KYTC RESPONSES TO COMMENTS RECEIVED

The majority of comments received during the 75275 Interchange virtual public Open House provided a direct answer to the questions asked and did not require a response. However, some comments received included a suggestion or question, or otherwise warranted a response from KYTC. Those comments are compiled in the tables below and responses from KYTC are provided.

SOUTH SECTION - I-71/75 Turfway Road Interchange

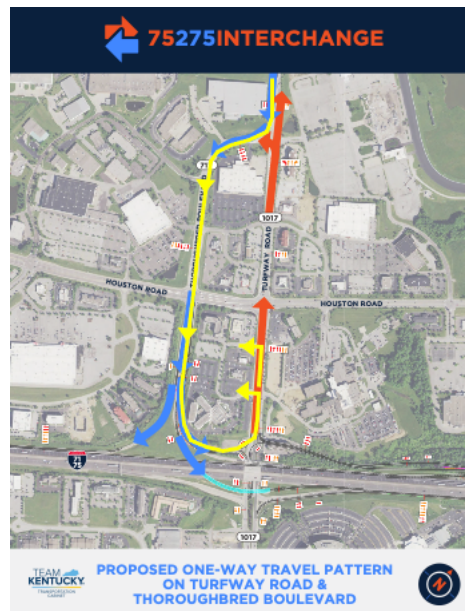
8. Southbound side the loppinh ramp to exit to Donaldson needs to be gone. Make the other ramp handle left and right turns. The light is already there,add a lane for left turns.

Removal of the existing loop ramp from southbound I-71/75 to eastbound KY 236 is proposed as part of the Recommended Alternative, and the existing southbound ramp from I-71/75 to KY 236 would be widened to four lanes to provided two right-turn lanes and two left-turning lanes at the traffic signal on KY 236.

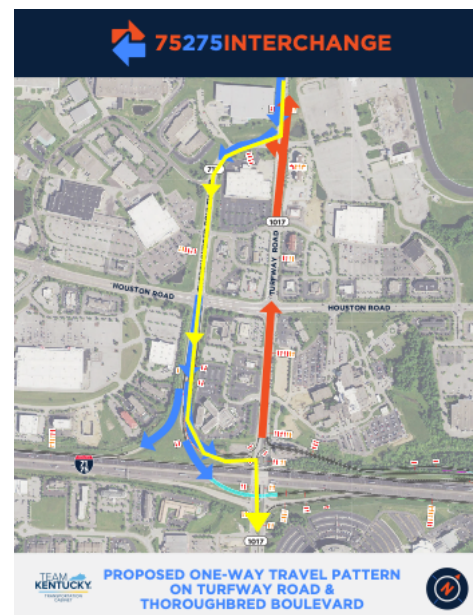
2. Changing turfway to a one way. How are people supposed to access burlington pike from turfway?

Motorists desiring to reach Burlington Pike east of I-71/75 from Turfway Road west of I-71/75 would turn left at any of Houston Road, Hansel Avenue, or Thoroughbred Boulevard intersections; turn left again onto Thoroughbred Boulevard (if on Houston or Hansel); travel along Thoroughbred Boulevard toward I-71/75; take the new proposed access ramp back to Turfway Road, turn right onto Turfway Road, pass under the bridge and turn right to Burlington Pike. One advantage of this new traffic flow configuration is that motorists would bypass much of the traffic and traffic lights on Turfway Road.

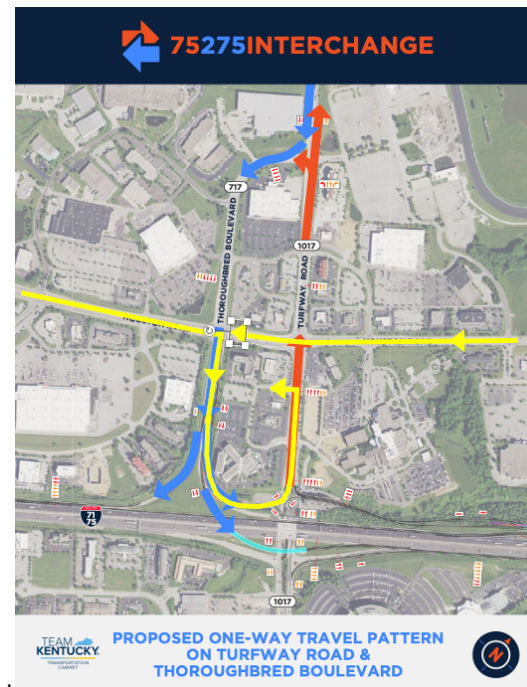
3. Why add one way streets?? That would only add confusion. The area is too commercial, one way streets would make access to business and the hospital/ doctor's offices more difficult. One way roads would also add more traffic to the streets/business parking

lots around Houston Rd, which are too small to handle a traffic increase.

- 4. How will this affect access to the businesses? For instance, if you are on Houston Rd how would you get to Cracker Barrel? Would you have to get on the highway, head north, turn around at Donaldson, and then head back south?

Houston Road and other surrounding streets will be explored in more depth in the next phase of development.

As the Recommended Alternative is currently configured, motorists on Houston Road desiring to reach Cracker Barrel would turn onto Thoroughbred Boulevard, proceed in the direction toward I-71/75, take the new, proposed access ramp to Turfway Road (this would run between the highway and the Hilton), turn left onto Turfway Road, proceed north on Turfway Road, turn left onto Steeple Chase Drive, and turn right into the Cracker Barrel entrance. However, improved access to businesses will be further explored in the next phase of project development, and it's possible that more direct access routes to local businesses and restaurants can be provided from Houston Road and Thoroughbred Boulevard

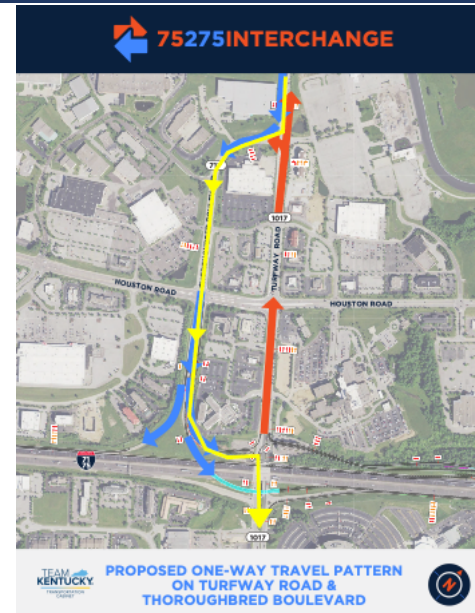
5. You're essentially making a "jug handle" to get to the restaurants off Houston (Cracker Barrel, raffertys, etc.)
ALL of Boone county HATES the jug handle on 42. It's time consuming, confusing, and inefficient. Not to mention the loss of business from people not having direct access from Houston (unless you can add access from the new proposed loop?)

6. One way traffic is not ideal for many of the businesses on that section of the road, and how will it impact hospital access?

7. How would people who live on the other side of 75 off turfway road get back to their house if turfway was a one way road?!?!??? You are cutting off our neighborhood access to accommodate for a highway problem.

As with some other one-way couplets, travel in the proposed design will be in a counterclockwise direction along streets and ramps to reach one's destination. All current business access would still be provided in the Recommended Alternative. Improved access to businesses will be further explored in the next phase of project development, and more direct access routes to local businesses and restaurants will be evaluated.

Hospital access will change depending upon the direction of travel. Accessing the hospital from northbound I-71/75 and points east of I-71/75 along Turfway Road will not change. From points west of I-71/75, one would travel Thoroughbred Boulevard and take the new, proposed access ramp to Turfway Road (this would run between the highway and the Hilton). Hospital access from southbound I-71/75 will actually be improved (shortened) by the addition of the ramp from southbound I-71/75 directly to Turfway Road.

In the Recommended Alternative, Turfway Road is proposed to be one-way for only a portion of the road on the west side of I-71/75. Turfway Road will remain two-way under the I-71/75 bridge and east of there. If you are west of I-71/75 and desire to reach Turfway Road east of I-71/75, you would travel along Thoroughbred Boulevard toward I-71/75, take the new, proposed access ramp to Turfway Road (this would run between the highway and the Hilton), turn right onto Turfway Road and pass under I-71/75. One advantage of this new traffic flow configuration is that motorists would bypass much of the traffic and traffic lights on Turfway Road.
